UNITED STATES PATENT AND TRADEMARK OFFICE

APPLICATION NO.	FILING DATE	FIRST NAMED INVENTOR	ATTORNEY DOCKET NO.	CONFIRMATION NO.
10/708,469	03/05/2004	Neil Thorburn	4019	2468
31424	7590	10/05/2004	EXAMINER	
BABCOCK IP LLC 24154 LAKESIDE DRIVE LAKE ZURICH, IL 60047			NGUYEN, PHUONGCHI T	
			ART UNIT	PAPER NUMBER
			2833

Office Action Summary	Application No. 10/708,469	Applicant(s) THORBURN, NEIL	
	Examiner Phuongchi Nguyen	Art Unit 2833

DETAILED ACTION

☒ Attachment 1

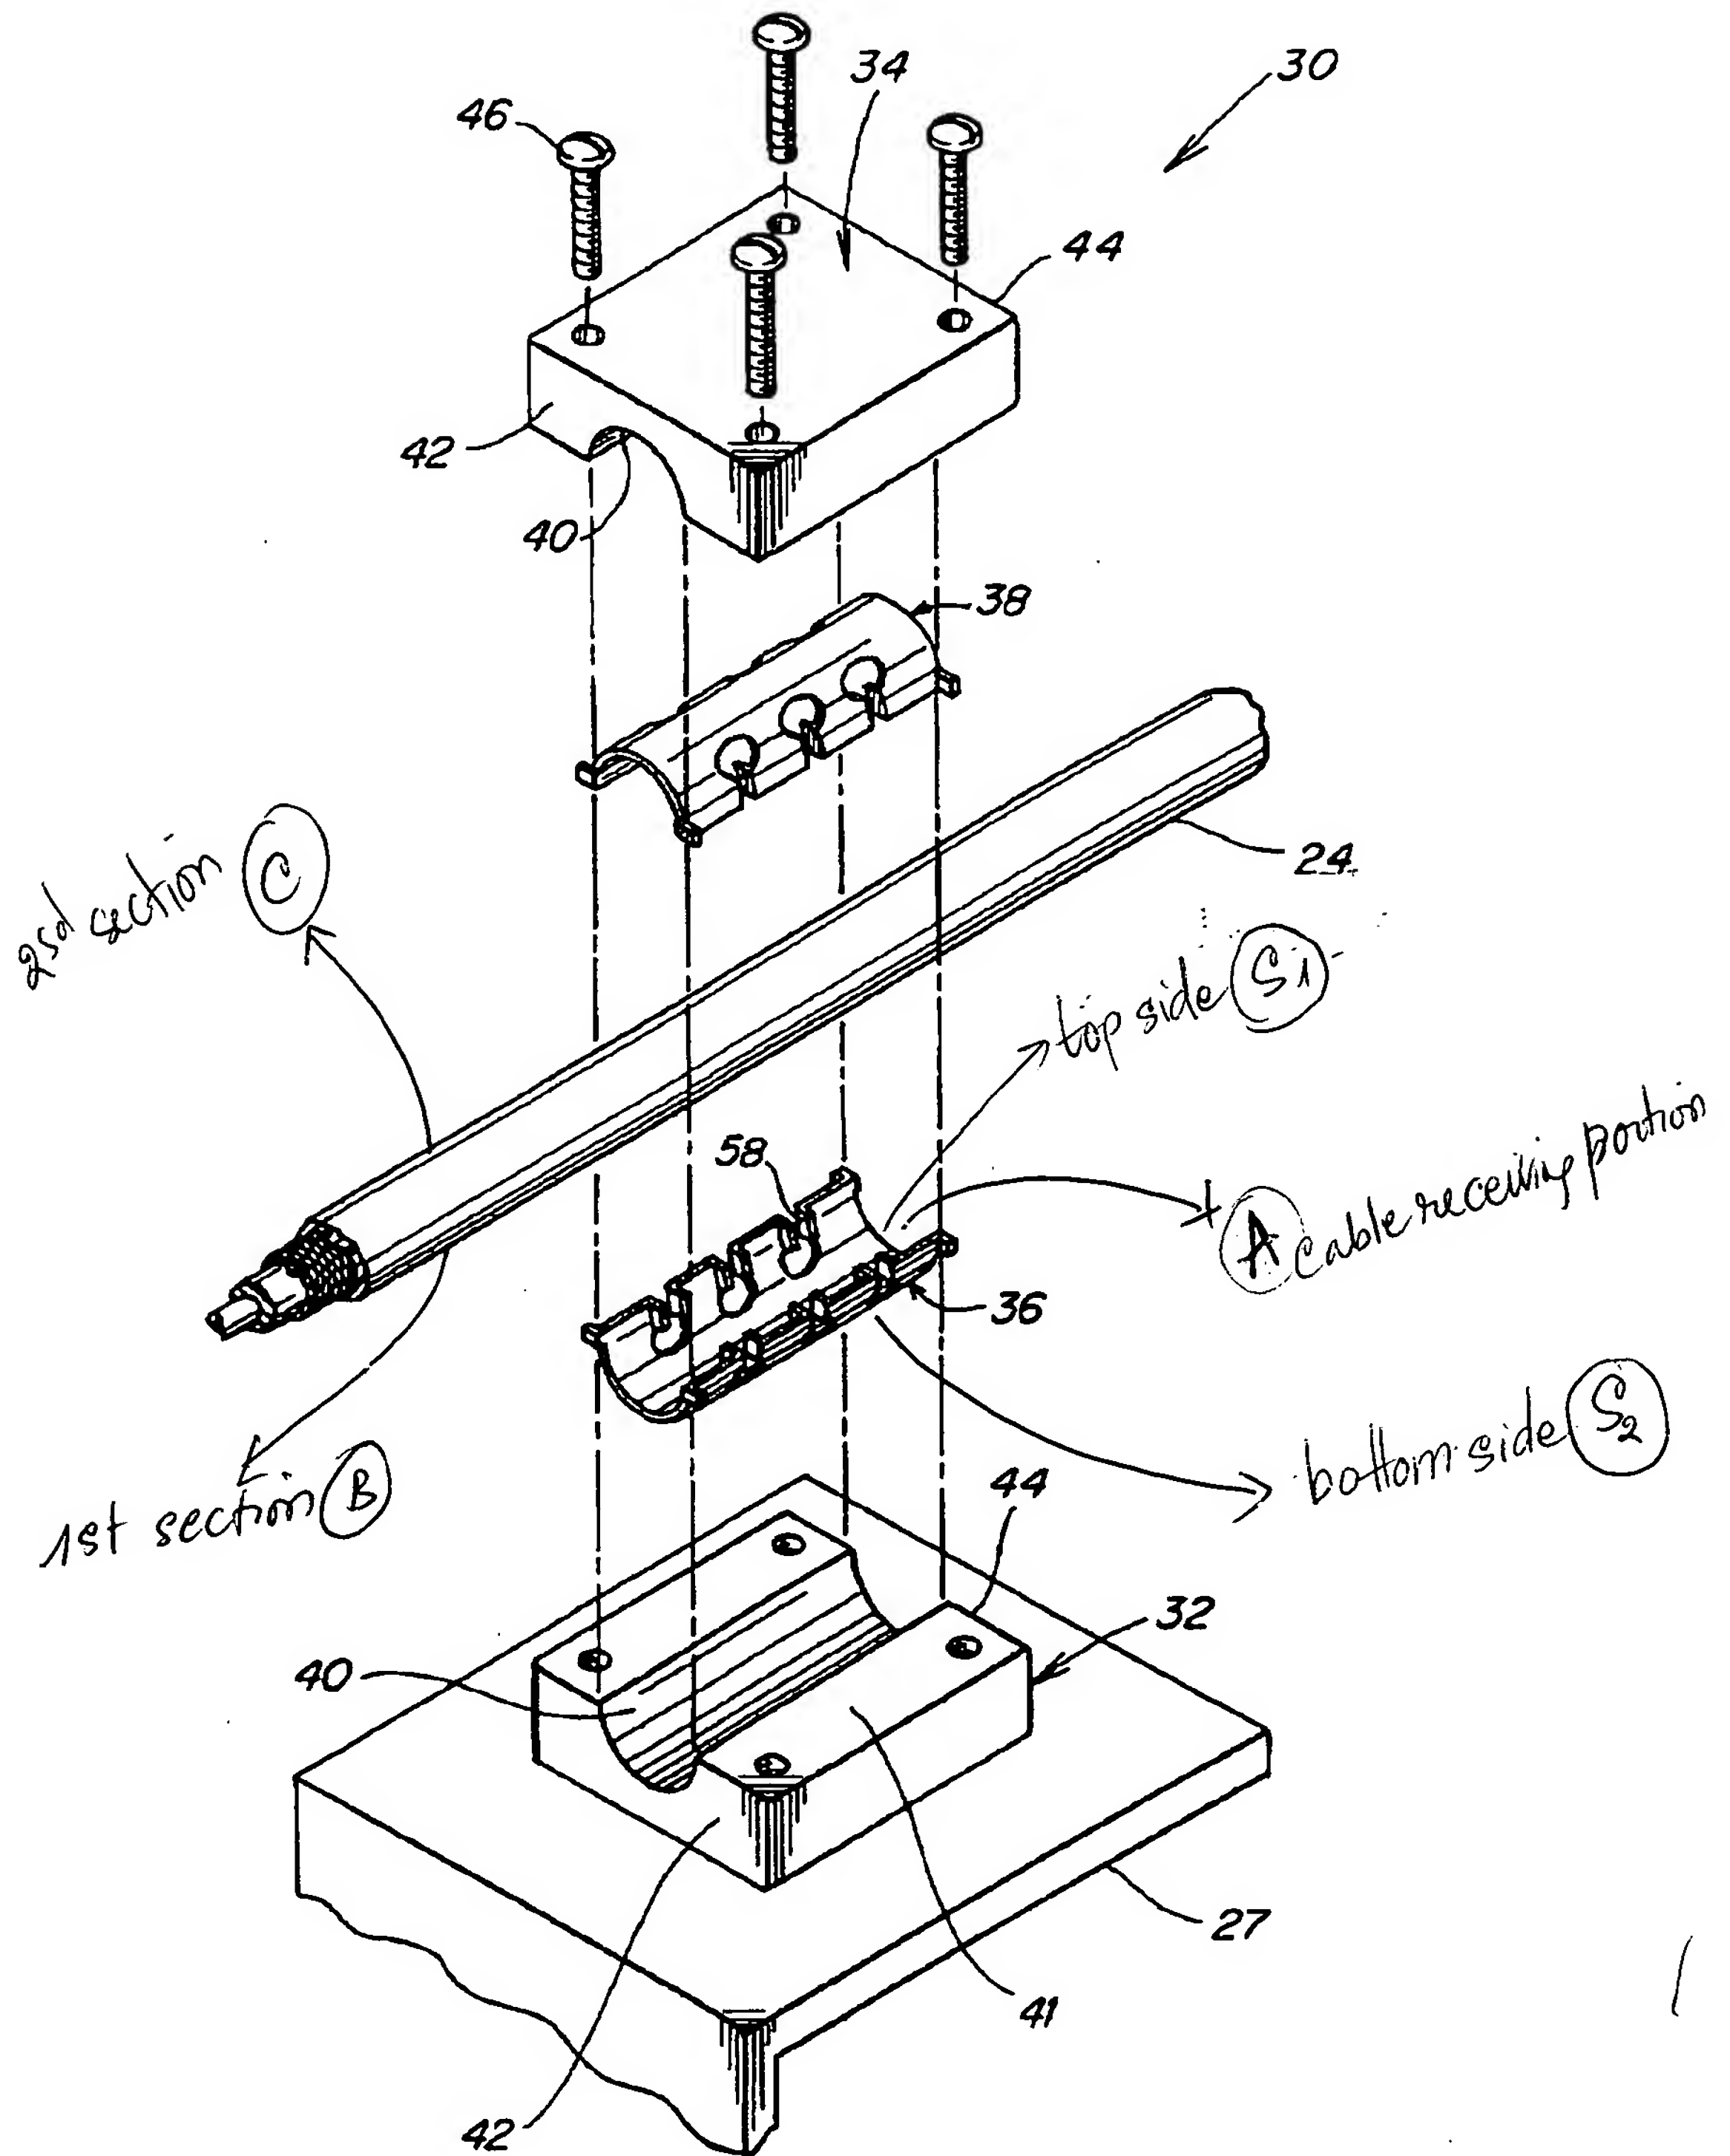
In regarding to claim 1, Mulvihill discloses (Attachment 1) a grounding assembly for the outer conductor of a plurality of electrical cables, comprising a ground strap (36) with a plurality of cable receiving portions (A) (figure 5) formed in a first side (top side S1); each of the cable receiving portions (A) to mate with a first section (B) of an outer diameter of the outer conductor of each of the electrical cables (24), a retaining insulator (34) to mate with the first side (S1) of the ground strap (36); the retaining insulator (34) having a plurality of cable retaining portions (40) (figure 5) to mate with a second section (C) of the outer diameter of the outer conductor of electrical cables (24) in the cable receiving portions (A), and a support insulator (32) to mate with a second side (bottom side S2) of the ground strap (36).

In regarding to claim 2, Mulvihill discloses (Attachment 1) the assembly wherein the ground strap (36) is formed from a single piece of material.

In regarding to claim 3, Mulvihill discloses (Attachment 1) the assembly wherein the ground strap (36) has a cross sectional area of 12 millimeter-squared (the thickness of the ground strap 36 is equal to (figure 4) the diameter D^1 of cable receiving hole subtracts to the diameter D^2 of the inner side (or top side S1) of the ground strap 36, (column 6, lines 3-11) that is:

$$\begin{aligned} A &= \pi (R^1)^2 - \pi (R^2)^2 \\ &= \pi ((R^1)^2 - (R^2)^2) \\ &= \pi ((0.250)^2 - (0.241)^2) \\ &= \pi (0.004419) \\ &= 0.0188 \text{ in}^2 \\ &= 0.0188 \text{ in}^2 ((25.4 \text{ mm})^2 / (1 \text{ in}^2)) = 12 \text{ mm}^2 \end{aligned}$$

In regarding to claim 4, Mulvihill discloses (Attachment 1) the assembly wherein each cable receiving portion (A) has at least one lip edge (73) (figure 5) protruding radially inward whereby the outer conductor (of the cable 24) is retained within the cable retaining portion (40) upon insertion.
